Subject: Pre-Application Summary Notes for Pointer Road Park

PRE-APPLICATION CONFERENCE
MEETING SUMMARY NOTES
Prepared for
Baker Loop Park
PA2023-0002, January 18, 2023

PRE-APPLICATION CONFERENCE MEETING SUMMARY

Pre-Application Conference Number: PA2023-0002

Magenta - West Slope Water Line
Orange - City of Beaverton Storm Line
Red - City of Beaverton Sanitary Sewer Line

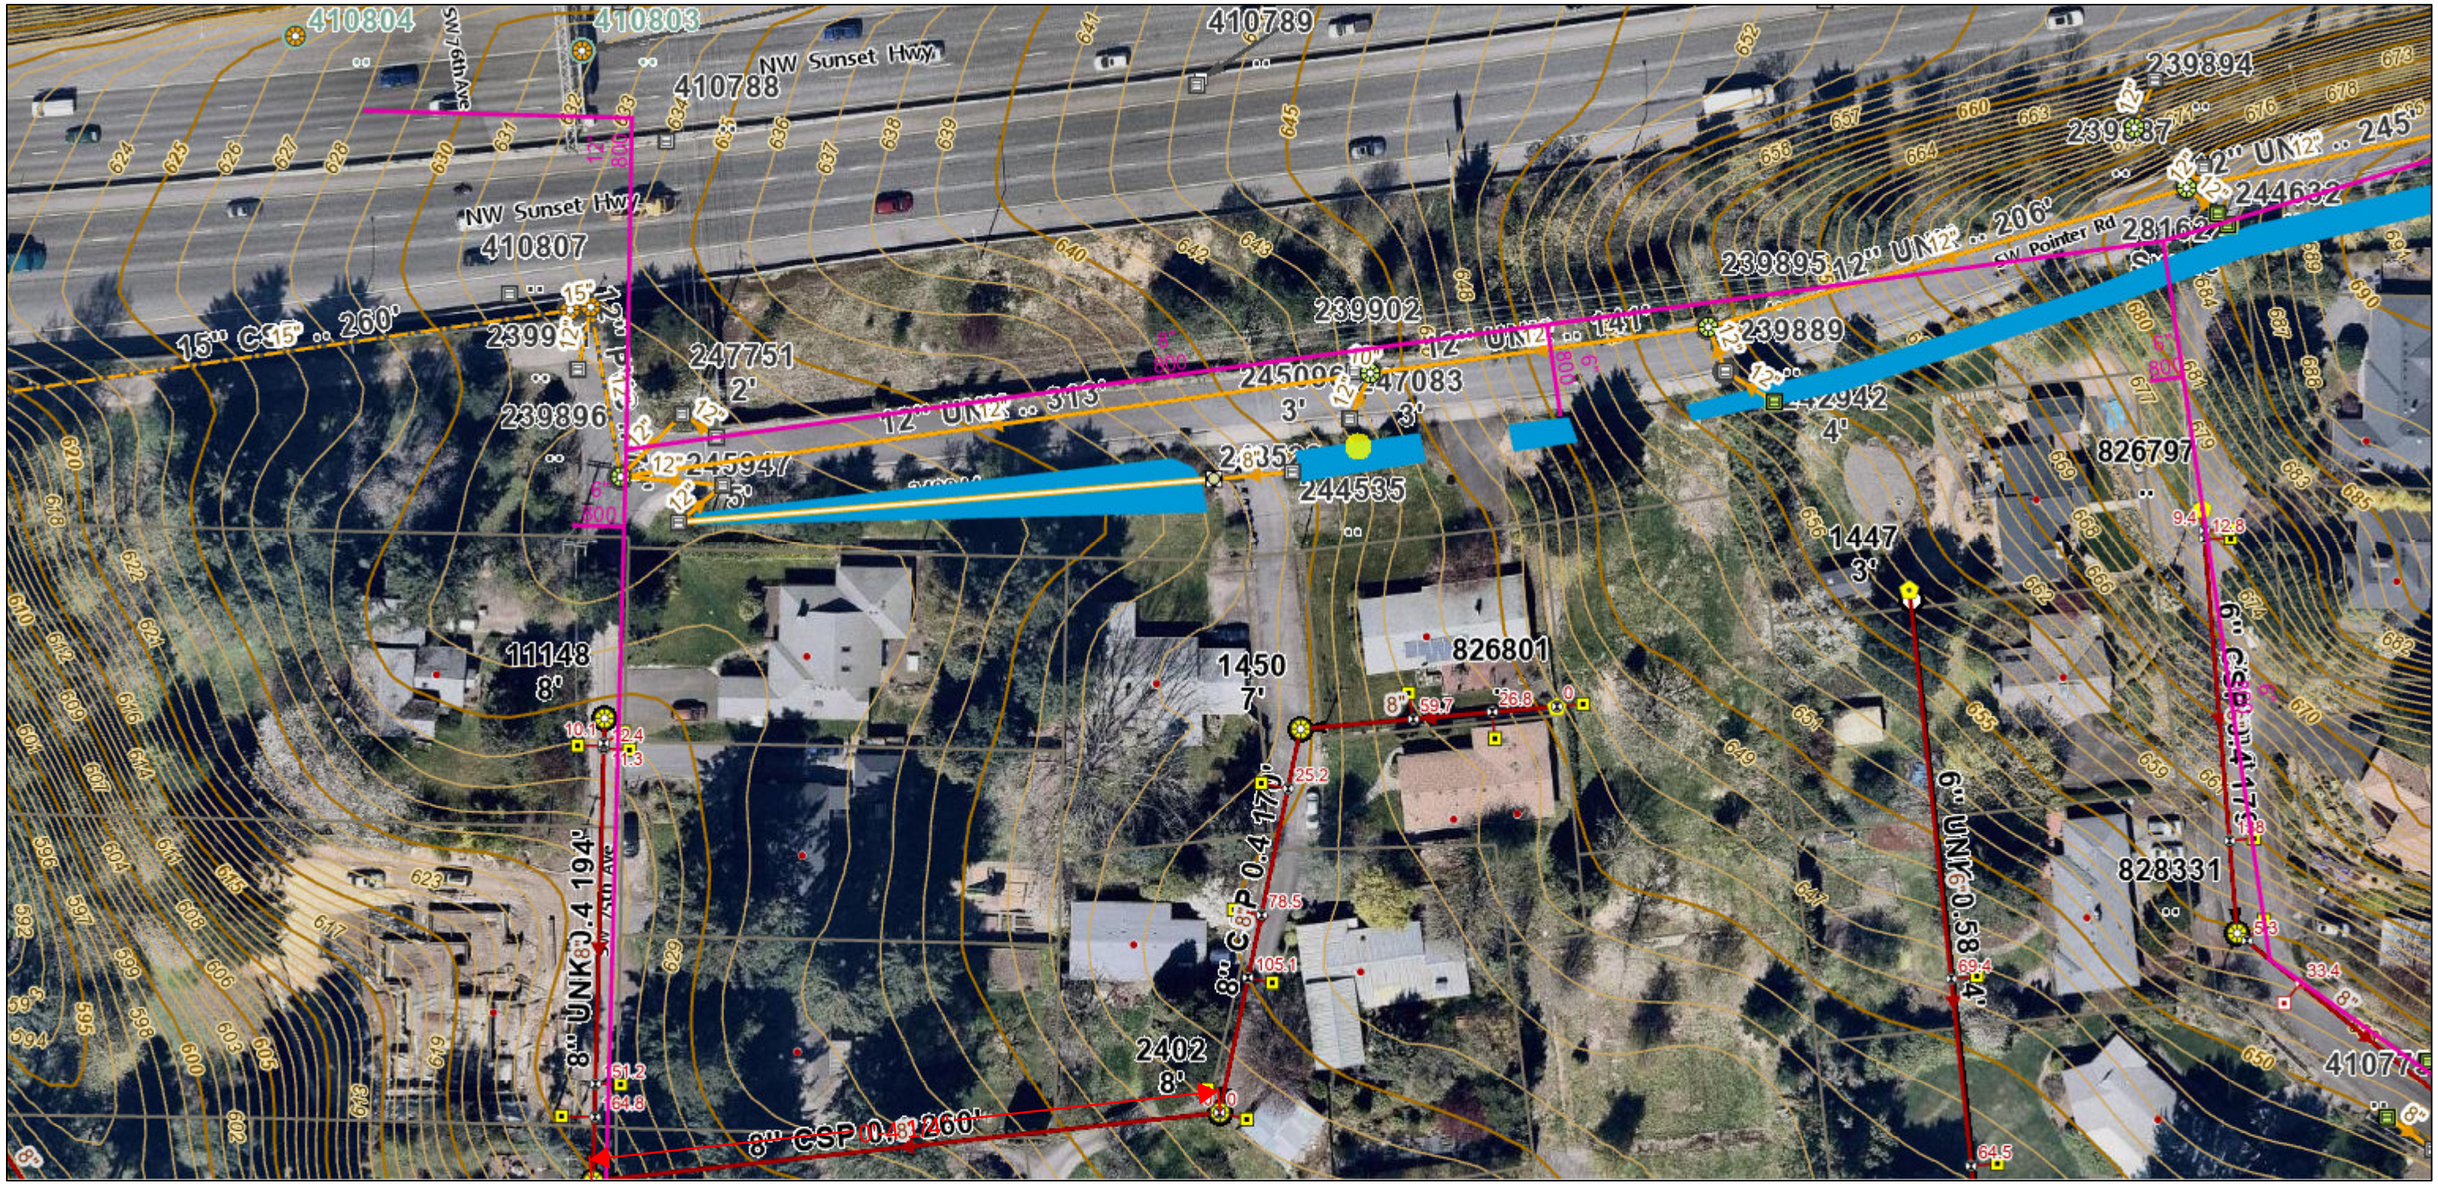
City of Beaverton sanitary sewer and storm drainage are in the vicinity of this project and can serve this site. There is a public 8" City-owned sanitary line running through private property adjacent to the proposed site. This line can serve the site if any bathrooms are proposed. Please note that maintenance access to this sanitary line by the City may not be impeded by the proposed construction. Additionally, utility laterals may not cross property lines unless contained in an easement.

The most immediate storm system connection is to a City-owned 8" storm line in SW Canyon Ln. Full on site mitigation of water quantity, quality, and hydromodification will be required as the new and modified impervious area exceeds 12,000 SF. There is also an existing storm swale to the north
